PLAN-009789

Proposal: Two storey side extension to replace garage & single storey rear extension.

Site: 9 Elmcroft Place, Aldingbourne, PO20 3XL.

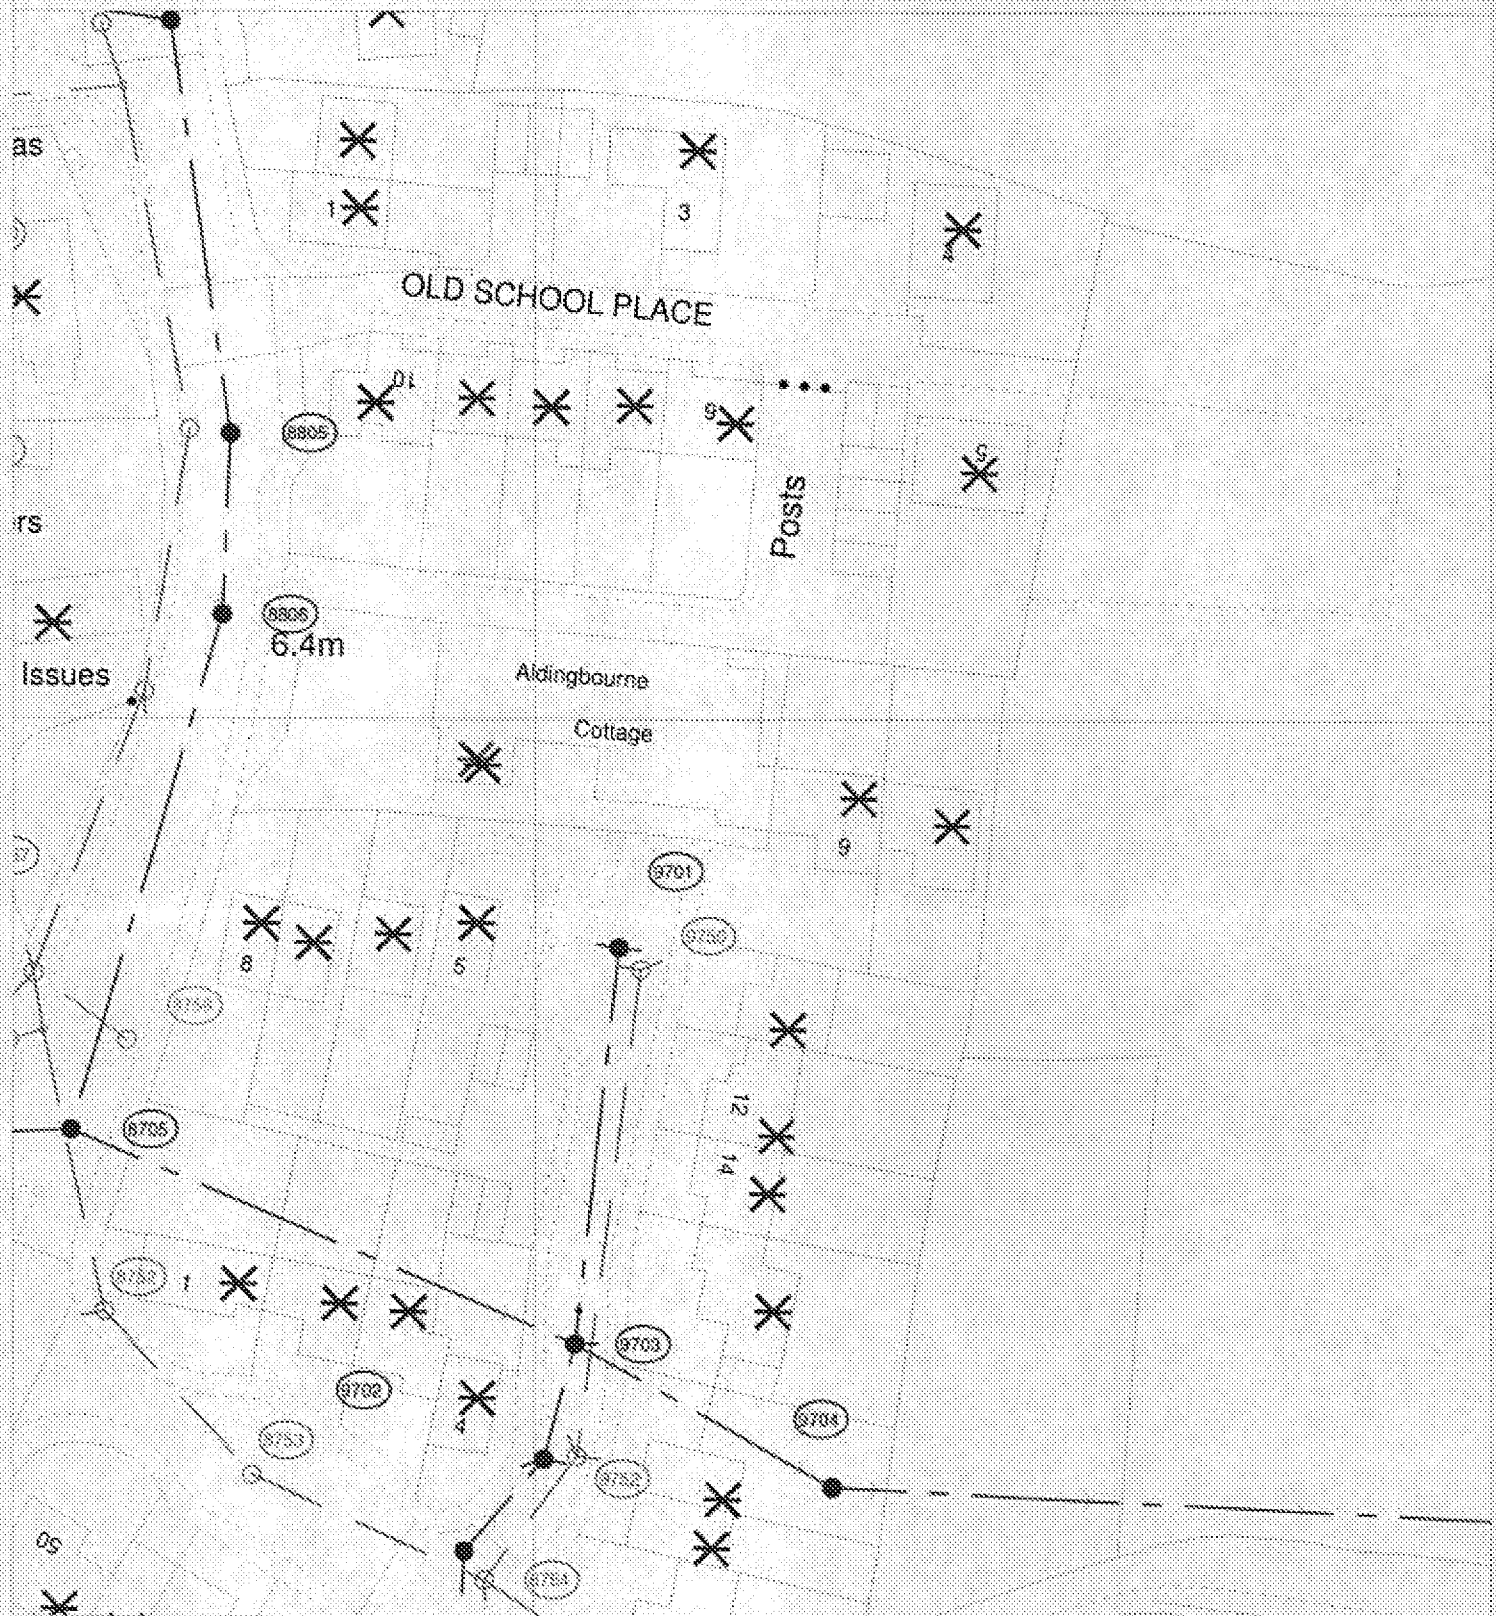
Due to changes in legislation that came in to force on 1st October 2011 regarding the future ownership of sewers it is possible that a sewer now deemed to be public could be crossing the above property. Therefore, should any sewer be found during construction works, an investigation of the sewer will be required to ascertain its condition, the number of properties served, and potential means of access before any further works commence on site.

The positions of pipes shown on this plan are believed to be correct, but Southern Water Services Ltd. accepts no responsibility in the event of inaccuracy. The actual positions should be determined on site.

The applicant is advised to discuss the matter further with Southern Water, Sparrowgrove House Sparrowgrove, Otterbourne, Hampshire SO21 2SW (Tel: 0330 303 0119) or www.southernwater.co.uk.
